**NERSA EVALUATION REPORT FOR ESKOM
NORTH WEST OPERATING UNIT –
DISTRIBUTION NETWORK PLANNING FOR
COMPLIANCE WITH THE GRID CODE
REQUIREMENTS**

**FINANCIAL YEAR
2016/17**

Figure 1: Eskom NW OU planning process for project approval, source: Eskom Planning Methodology for NMPs and NDPs, page 28

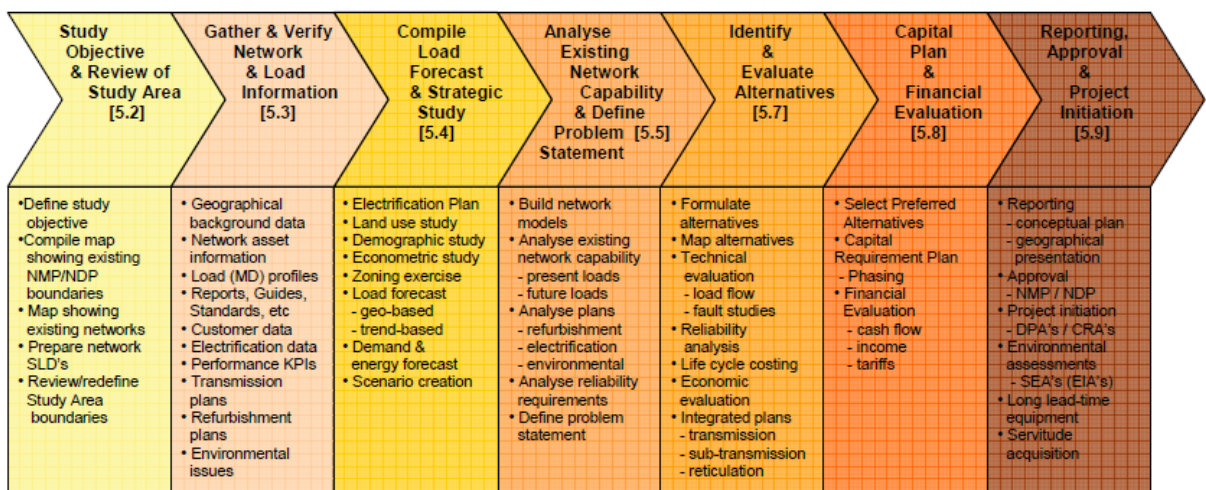
However, these processes and procedures are not followed extensively as Eskom NW OU excludes all refurbishment projects from the planning process as depicted in Figure 1. More precisely, there is a thin line between choosing a refurbishment project and a strengthening project. A refurbishment project may recommend the replacement of a transformer with one of the same size, but if the planning processes have been followed, it might recommend that the old transformer be replaced with the one of a larger size as the load forecast of the area predicts growth in the area. This then becomes an oversight on Eskom NW OU’s side as all of its refurbishment projects miss this opportunity to make informed technical and prudent investment decisions.

| Finding | Management response on the finding |
|---|--|
| <ul style="list-style-type: none"> Eskom NW OU should use the same process to evaluate its projects, including refurbishment projects, which at this stage are being excluded from following the same process as defined by the methodology for NMPs and NDPs. | <ul style="list-style-type: none"> Refurbishment projects are identified by the Plant Department after evaluating the condition of the plant in question. The refurbishment plan for the area under the planning review is then integrated into the NDP process for assessment. Should any strengthening and / or reliability conditions be identified during this process, then the categorisation of the “refurbishment project” may change, depending on the pre-eminent need identified during this process. Should no additional needs be identified, then the project will continue to be handled as a refurbishment project. Refurbishment projects are considered as part of the NDP process and are thus integrated as per the defined methodology for the creation of NMP’s and NDP’s. These projects don’t follow the same process as strengthening projects due to the fact that it’s replacement of like with like. |
| Management Action Plan to correct the findings | <ul style="list-style-type: none"> Existing process and procedures for project identifications will be followed. |

Figure 4: Summary of audit findings for Gopane-Dinokana 22kV Feeder Split Project

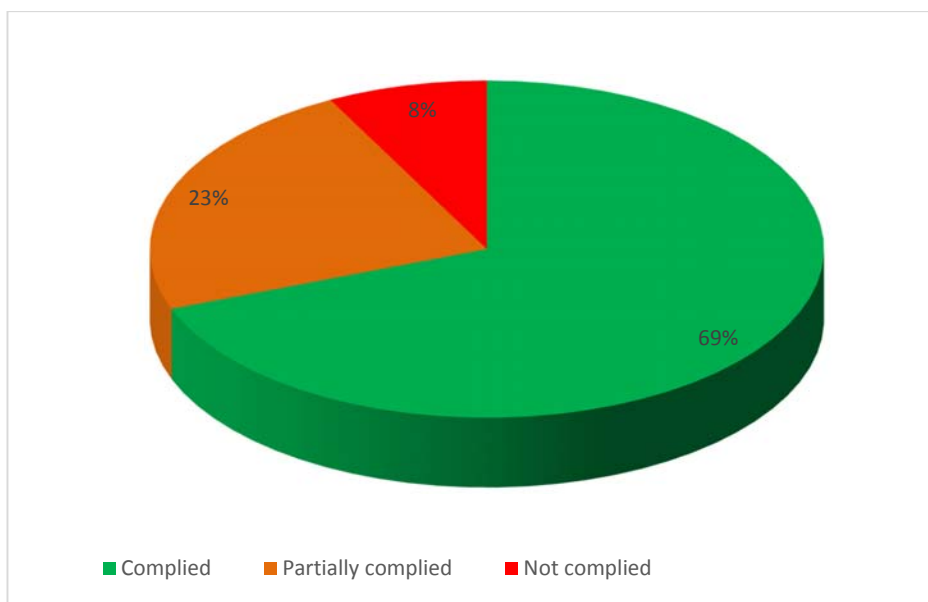
The section of the Grid Code requirements that Eskom NW OU did not comply with on this project are as follows:

- Eskom NW OU should use the NERSA-approved values for the COUE.
- PEM should be improved in order to estimate all the relevant costs involved to execute the evaluated alternatives after those alternatives have met the technical requirements. PEM in its current state omits many relevant costs in order to be sure that the preferred option is the least cost alternative as the Grid Code promotes the least cost planning.

- Eskom NW OU should improve the content of its NDPs as it is too summarised to enable someone who is not involved in the daily planning of Eskom NW OU's network to understand the network problems and the solutions thereto. The executive summary of NDPs as presented by Eskom NW OU to the NERSA Audit Team are only meant for Eskom NW OU's management (i.e. mainly for Engineering Manager, Network Services Manager, Capital Programme Manager, Electricity Delivery Manager and Field Services Manager) to make sound capital investment decisions as detailed in Eskom Planning Methodology for NMPs and NDPs.

| <p>Management Action Plan to correct the findings</p> | <ul style="list-style-type: none"> • Management will strive to use latest approved values by NERSA at all times. • A process to ensure that PEM results are checked by an investment specialist or Network Planning Manager is in place. • Meeting will be arranged with NERSA to further improve the PEM applicability and other components that might be included on the PEM tool to improve the selection of options. |

Figure 6: Summary of audit findings for Mafikeng Main 88/33/11kV Substation Refurbishment Project

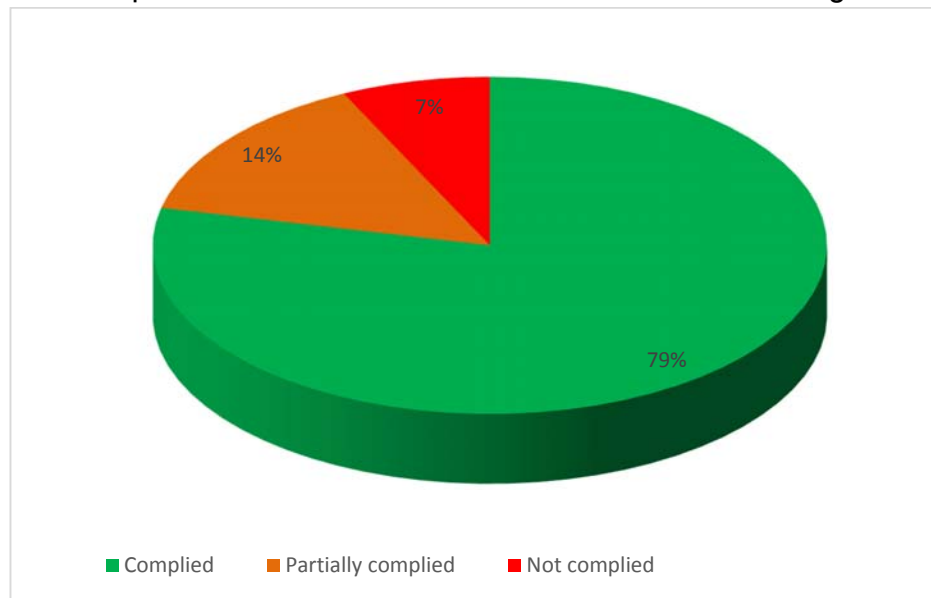
The section of the Grid Code requirements that Eskom NW OU did not comply with are as follows:

- Eskom NW OU should use the NERSA-approved values for the COUE.
- PEM should be improved in order to estimate all the relevant costs involved to execute the evaluated alternatives after those alternatives have met the technical requirements. PEM in its current state omits many relevant costs in order to be sure that the preferred option is the least cost alternative as the Grid Code promotes the least cost planning.

- Eskom NW OU should improve the content of its NDPs as it is too summarised to enable someone who is not involved on a daily planning of Eskom NW OU's network to understand the network problems and the solutions thereto. The executive summary of NDPs as presented by Eskom NW OU to the NERSA Audit Team are only meant for Eskom NW OU's management (i.e. mainly for Engineering Manager, Network Services Manager, Capital Programme Manager, Electricity Delivery Manager and Field Services Manager) to make sound capital investment decisions as detailed in Eskom Planning Methodology for NMPs and NDPs.

| Management Action Plan to correct the findings | <ul style="list-style-type: none"> • Management will strive to use latest approved values by NERSA at all times. • Meeting will be arranged with NERSA to further improve the PEM applicability and other components that might be included on the PEM tool to better improve the selection of options. |

Figure 8: Summary of audit findings for Oakland City Main Substation Project

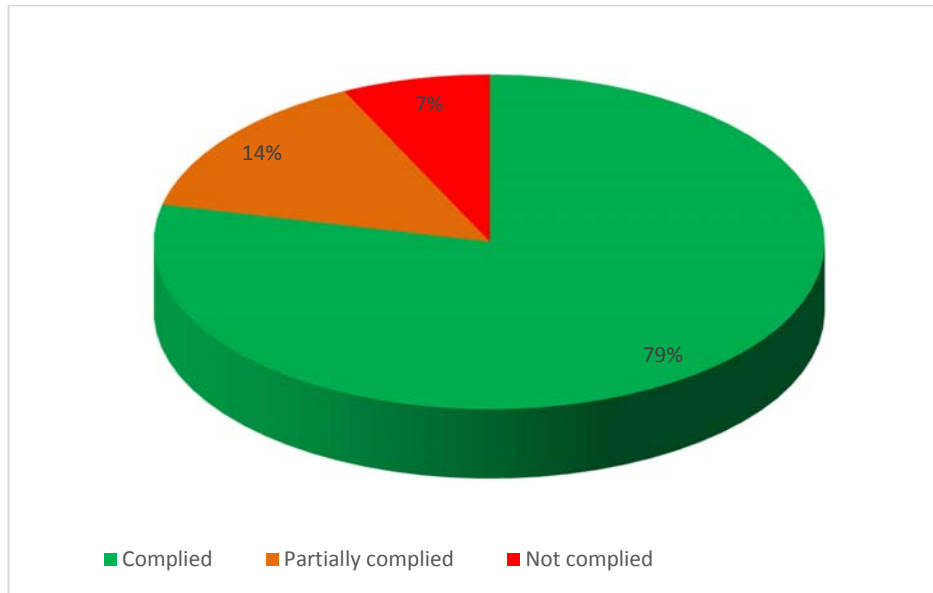
The details of the Grid Code requirement that Eskom NW OU did not comply with are as follows:

have met the technical requirements. PEM in its current state omits many relevant costs in order to be sure that the preferred option is the least cost alternative as the Grid Code promotes the least cost planning.

- Eskom NW OU should improve the content of its NDPs as it is too summarised to enable someone who is not involved on a daily planning of Eskom NW OU's network to understand the network problems and solutions. The executive summary of NDPs as presented by Eskom NW OU to the NERSA Audit Team are only meant for Eskom NW OU's management (i.e. mainly for Engineering Manager, Network Services Manager, Capital Programme Manager, Electricity Delivery Manager and Field Services Manager) to make sound capital investment decisions as detailed in Eskom Planning Methodology for NMPs and NDPs.

| Finding | Management response on the finding |
|--|---|
| Management Action Plan to correct the findings | <ul style="list-style-type: none"> • Management will strive to use latest approved values by NERSA at all times. • Meeting will be arranged with NERSA to further improve the PEM applicability and other components that might be included on the PEM tool to better improve the selection of options. |

Figure 10: Summary of audit findings for Straatsdrift Switching Station Project

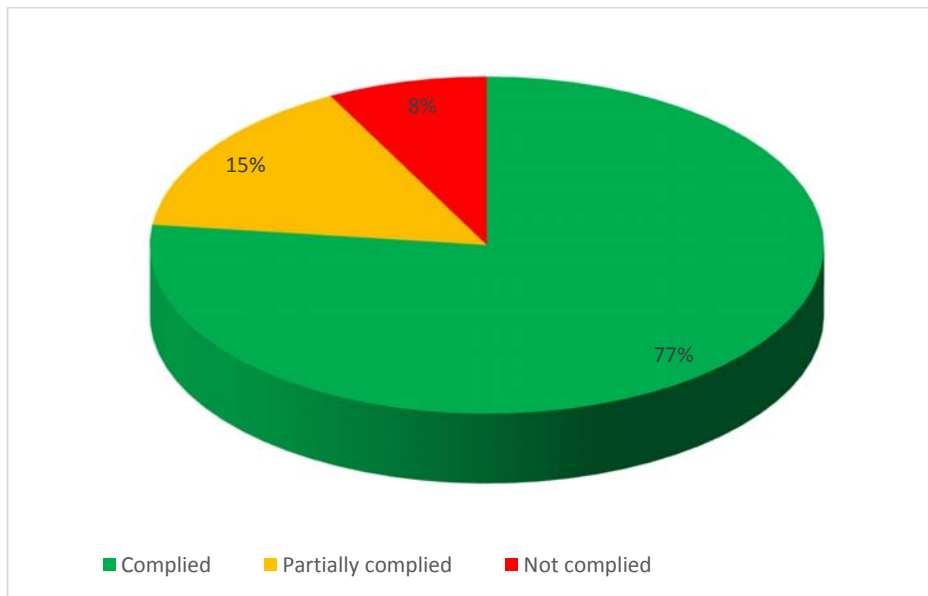
The section of the Grid Code requirements that Eskom NW OU did not comply with is as follows:

- Eskom NW OU should use the NERSA-approved values for the COUE.
- PEM should be improved in order to estimate all the relevant costs involved to execute the evaluated alternatives after those alternatives have met the technical requirements. PEM in its current form omits many relevant costs in order to ensure that the preferred option is the least cost alternative as the Grid Code promotes the least cost planning.

- Eskom NW OU should improve the content of its NDPs as it is too summarised to enable someone who is not involved on a daily planning of Eskom NW OU's network to understand the network problems and solutions. The executive summary of NDPs as presented by Eskom NW OU to the NERSA Audit Team are only meant for Eskom NW OU's management (i.e. mainly for Engineering Manager, Network Services Manager, Capital Programme Manager, Electricity Delivery Manager and Field Services Manager) to make sound capital investment decisions as detailed in Eskom's Planning Methodology for NMPs and NDPs.

| Finding | Management response on the finding |
|---|---|
| Management Action Plan to correct the findings | <ul style="list-style-type: none"> • Management will strive to use latest approved values by NERSA at all times. • Meeting will be arranged with NERSA to further improve the PEM applicability and other components that might be included on the PEM tool to better improve the selection of options. |

Figure 12: Summary of audit findings for Vryburg road substation strengthening and project

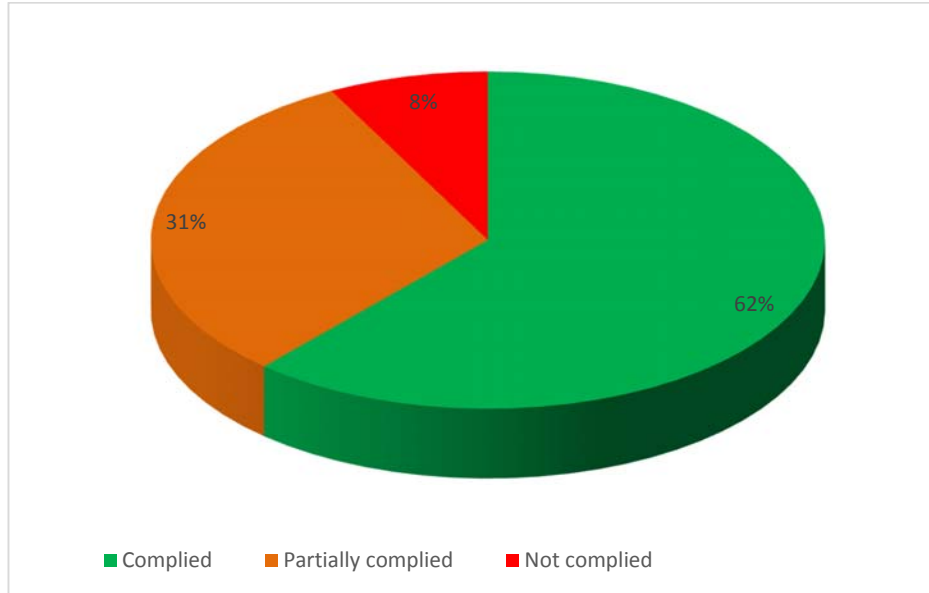
The section of the Grid Code requirements that Eskom NW OU did not comply with on this project are as follows:

- Eskom NW OU should use the NERSA-approved values for the COUE.
- PEM should be improved in order to estimate all the relevant costs involved to execute the evaluated alternatives after those alternatives have met the technical requirements. PEM in its current state omits many relevant costs in order to be sure that the preferred option is the least cost alternative as the Grid Code promotes the least cost planning.

- Eskom NW OU should conduct an audit to evaluate the condition of the substation equipment which will detail the refurbishment needs together with the estimated remaining life of the equipment in order to correctly estimate the disposal value(s) of those equipment.

- Eskom NW OU should improve the content of its NDPs as it is too summarised to enable someone who is not involved on a daily planning of Eskom NW OU's network to understand the network problems and solutions. The executive summary of NDPs as presented by Eskom NW OU to the NERSA Audit Team are only meant for Eskom NW OU's management (i.e. mainly for Engineering Manager, Network Services Manager, Capital Programme Manager, Electricity Delivery Manager and Field Services Manager) to make a sound capital investment decisions as detailed in Eskom Planning Methodology for NMPs and NDPs.

| <p>Management Action Plan to correct the findings</p> | <ul style="list-style-type: none"> • Management will strive to use latest approved values by NERSA at all times. • Existing processes on plant audits will be followed. • Constructability and implementation plan for the Vryburg Road Substation project will further be looked on at design stage to ensure minimum interruptions to customers. This process is in place already and checked by technical evaluation forum (TEF) in all designs for projects to ensure minimum interruption of supply. • Meeting will be arranged with NERSA to further improve the PEM applicability and other components |
